Silken Sewing Ltd - New building

Baniar Chala (Member Bari), Vobanipur, Gazipur

13th February, 2017

Inconsistent and missing documents

Typical Beam Column Layout

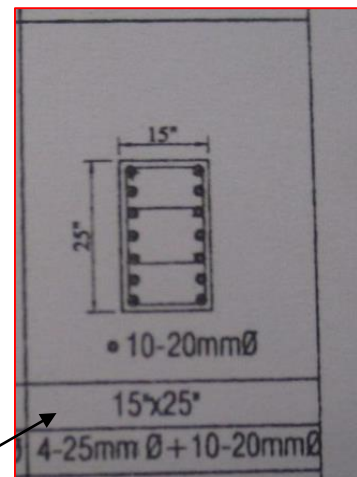
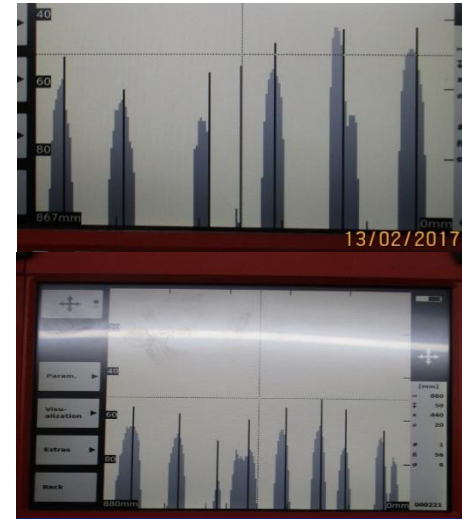
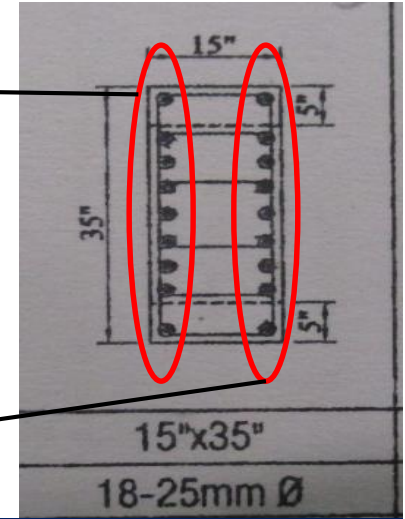
Found 12-20mm dia rebar in C-16 column on roof top but in column schedule, the rebar was different

Found 7 nos. and 8 nos. re-bars on first floor instead of 9 bars in column schedule of C-16 on long direction of column

Typical Beam Column Layout

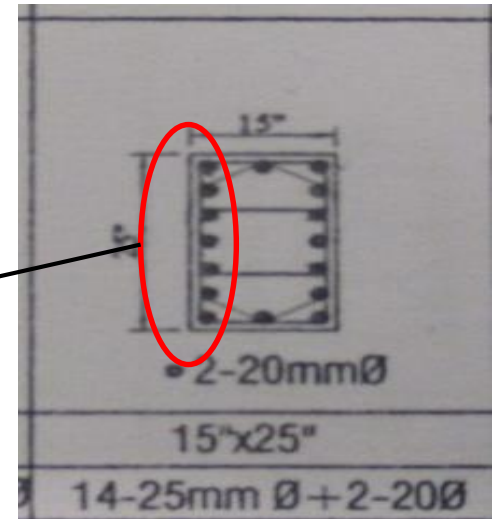
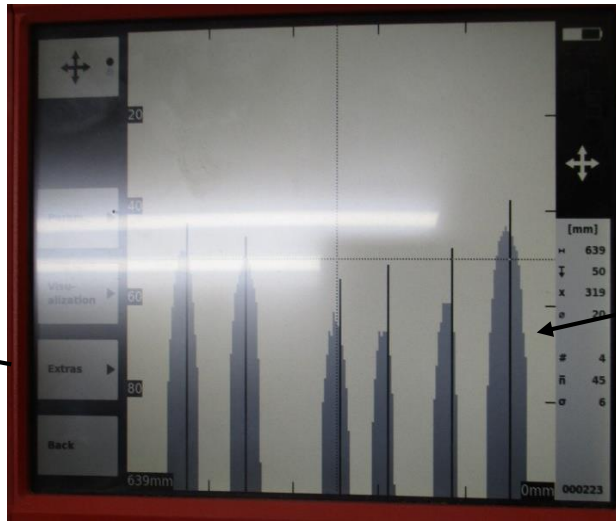
Found 6nos. rebar in C-15 column at one face on 1st floor but in column schedule, the rebar was shown 7nos.

C-12 column at 1st floor on stair case

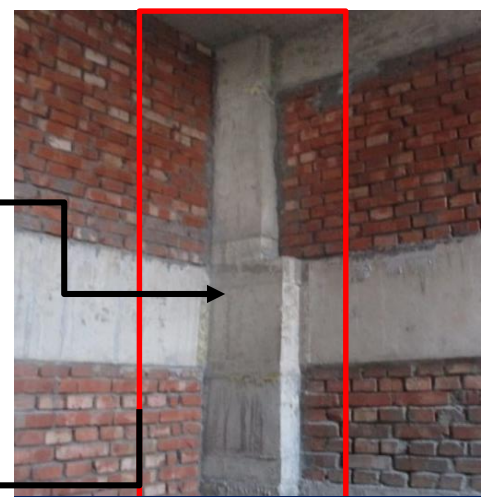
C-12 column size found different in stair case but according to provided column schedule, the size of column was shown same on Ground floor to roof top.

Typical Beam Column Layout

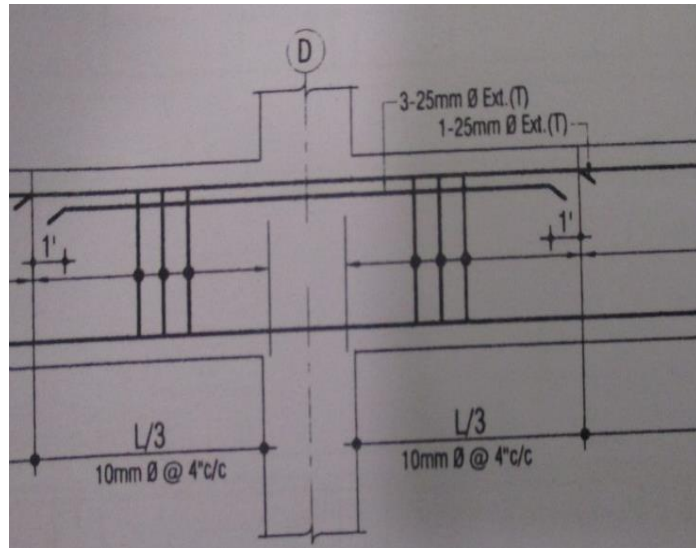
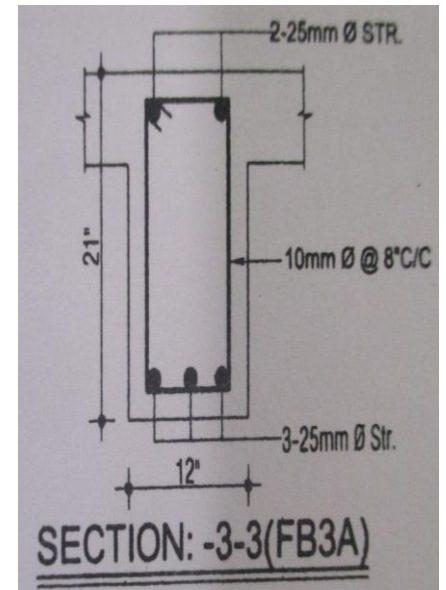
In provided drawing, the FB-3A beam has 6-25mm rebar as top bar and 3-25mm rebar as bottom bar

Found 3-25mm & 3-20mm re bar as top bar and 2-25mm & 1-20mm re bar as bottom bar on Fb-3A

The reinforcements in FB-3A was found less than in provided drawing

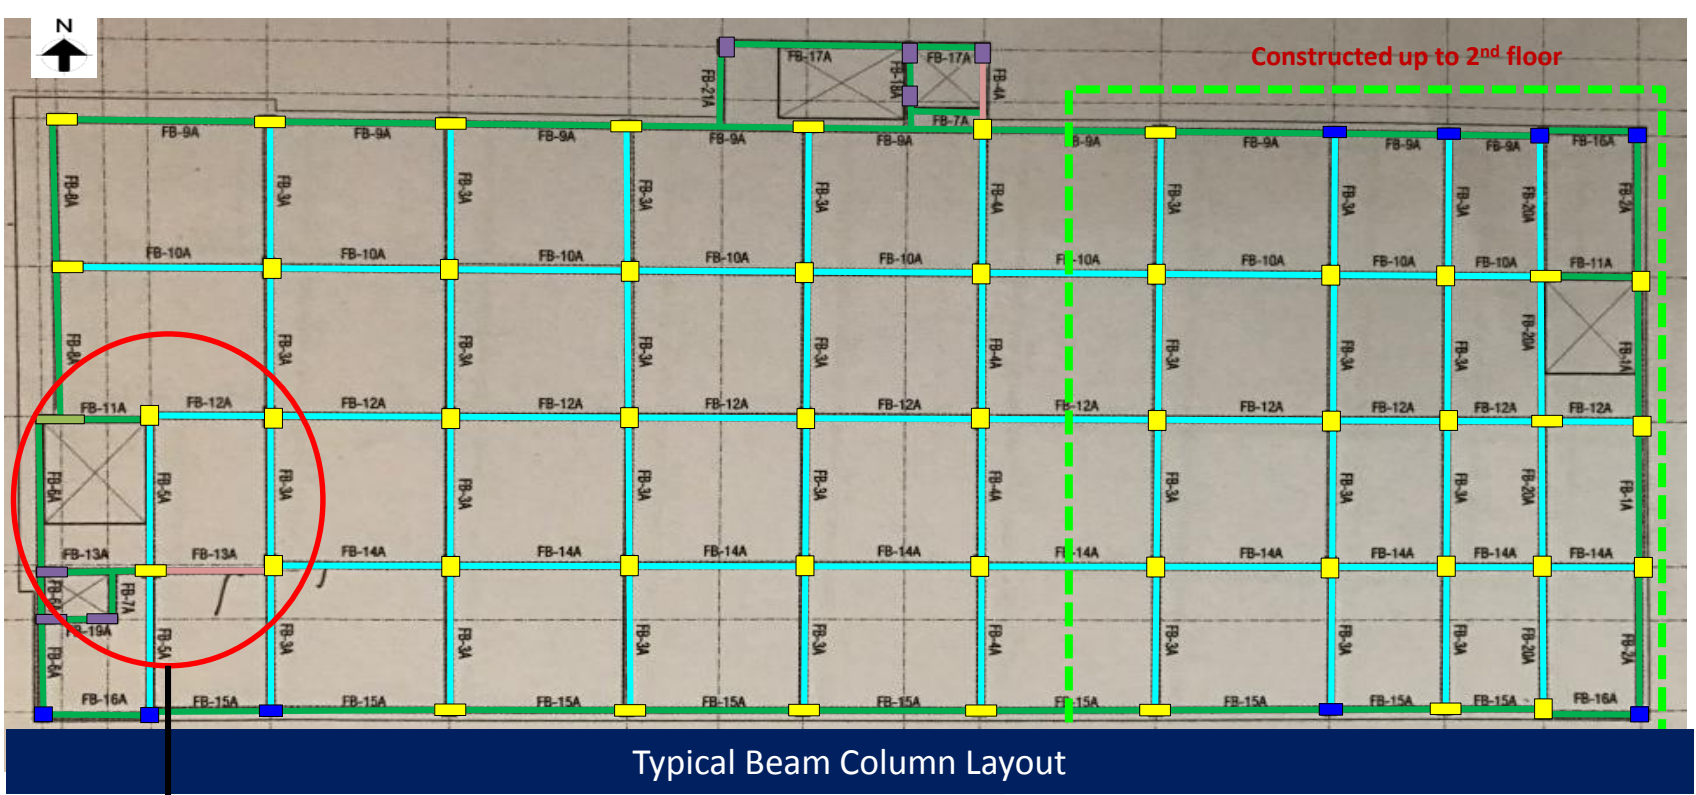
Found single RCC over head water tank on stair case

In provided drawing, no detail of over head water tank was found

5th floor Beam Column Layout

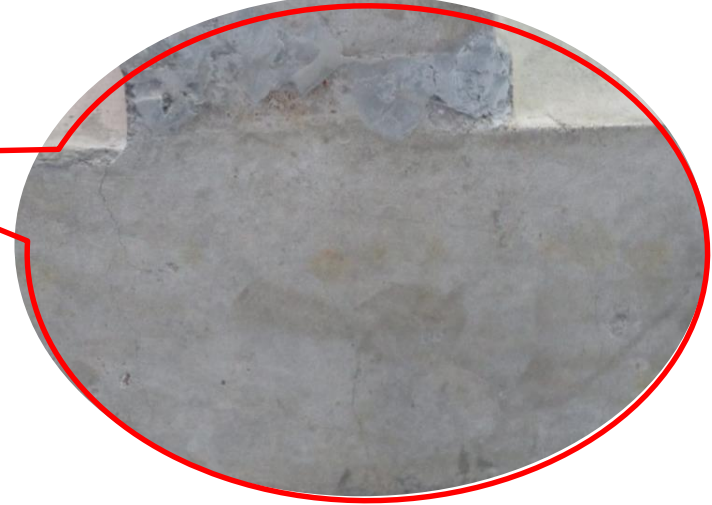
Crack observed on the joint of two beam

Item No.	Observation	Recommended Action Plan	Recommended Timeline
1	Inconsistent and missing documents	Engage a Building Engineer to survey the structure and update a full set of “as-constructed” drawings	6-weeks
2	Appearance Hairline crack observed on beams	Engage a Building Engineer to investigate if cracks penetrate the building structure.	6-weeks
3	Appearance Hairline crack observed on beams	Building Engineer to carry out design check on beam to confirm that these cracks are non-structural.	6-weeks
4	Appearance Hairline crack observed on beams	Carry out remedial works resulting from engineering assessment if necessary.	6-months
